MONTICELLO NUCLEAR GENERATING PLANT

REQUEST FOR AMENDMENT TO
OPERATING LICENSE NO. DPR-22

(License Amendment Request Dated March 11, 1976)

PROPOSED CHANGES TO THE TECHNICAL SPECIFICATIONS, APPENDIX A OF
PROVISIONAL OPERATING LICENSE DPR-22

Figure 1. Propose Nitrogen Recirculation System.

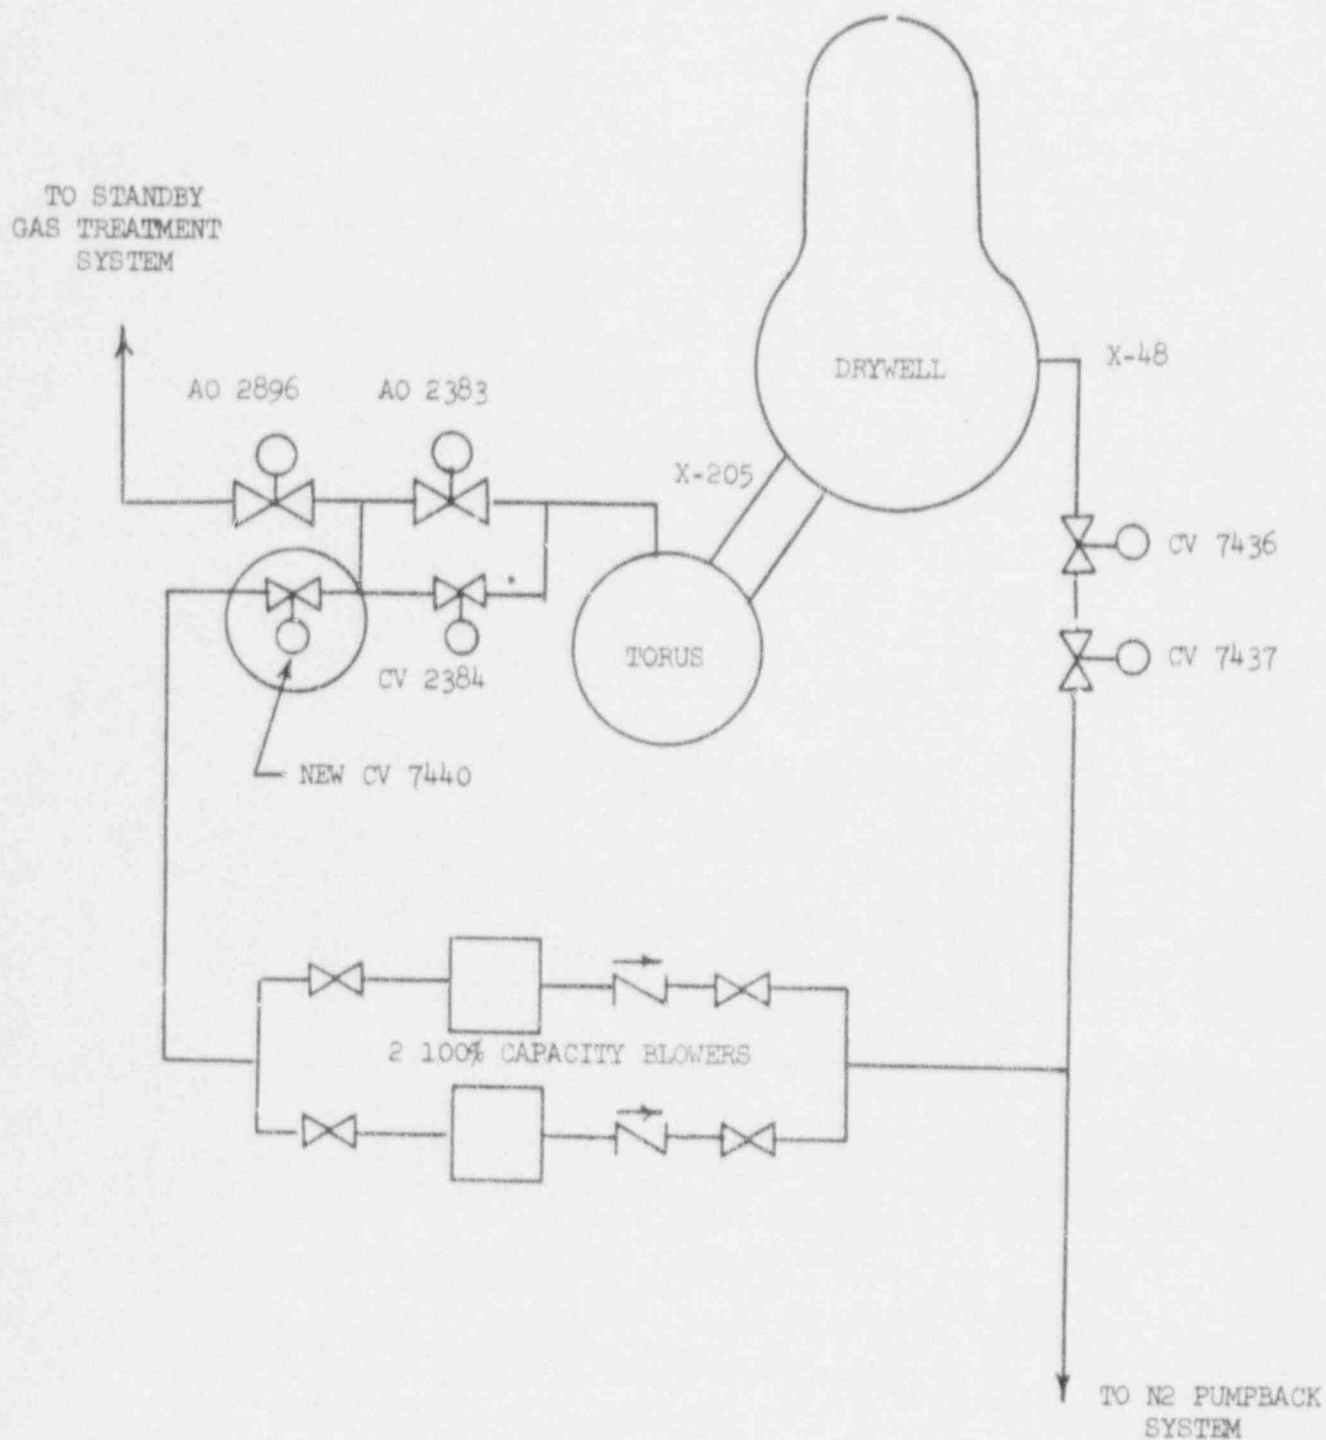
The proposed system (Figure 1) will remove nitrogen from the torus via CV-2384 and newly installed isolation valve CV-7440 using one of two blowers. The blower will discharge nitrogen to the drywell through two 1-inch isolation valves, CV-7437 and CV-7436, originally installed as part of a nitrogen pumpback system. Blower speed and recirculation flow will be manually adjusted to maintain the drywell pressure 1 psi above the torus pressure. The system, up to the second containment isolation valve in the suction and discharge lines, satisfies all design, quality assurance, and testability requirements set forth in 10 CFR 50.

Figure 2. Group 2 Isolation Logic for Outboard Isolation Valves.

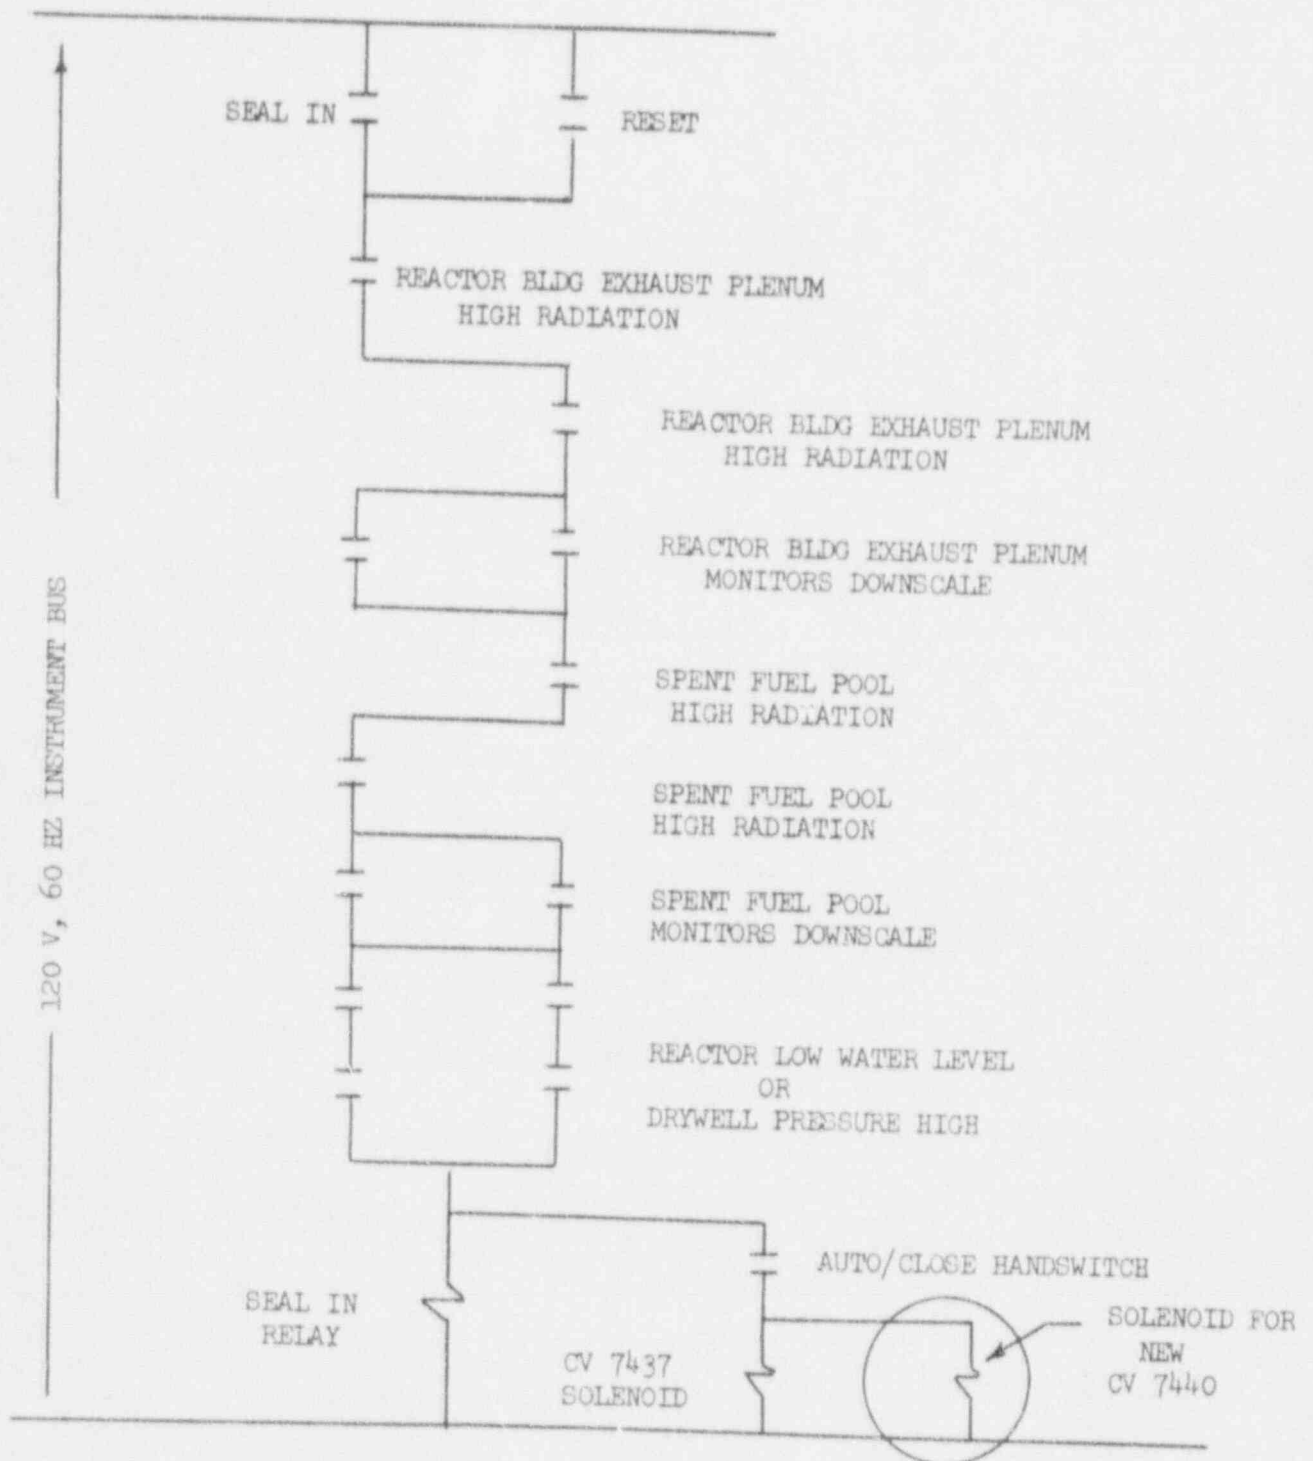
A new 2-inch control valve, CV-7440, will be installed in series with CV-2384 to provide for double isolation of the supply line coming from the torus vent header. This valve will be controlled by the same circuitry that controls the outboard N₂ Pumpback isolation valve, CV-7437.

Since the isolation logic for the outboard isolation valves is separate from the inboard valves, the necessary separation criteria required for isolation valves in series is satisfied (Figure 2).

CV-7440 will be provided with limit switches which indicate if the valve is open or closed. These limit switches will be wired in conjunction with the limit switches of CV-7437 so that both valves must be closed to get the proper indication in the control room. The handswitch for CV-7437 will also control CV-7440.
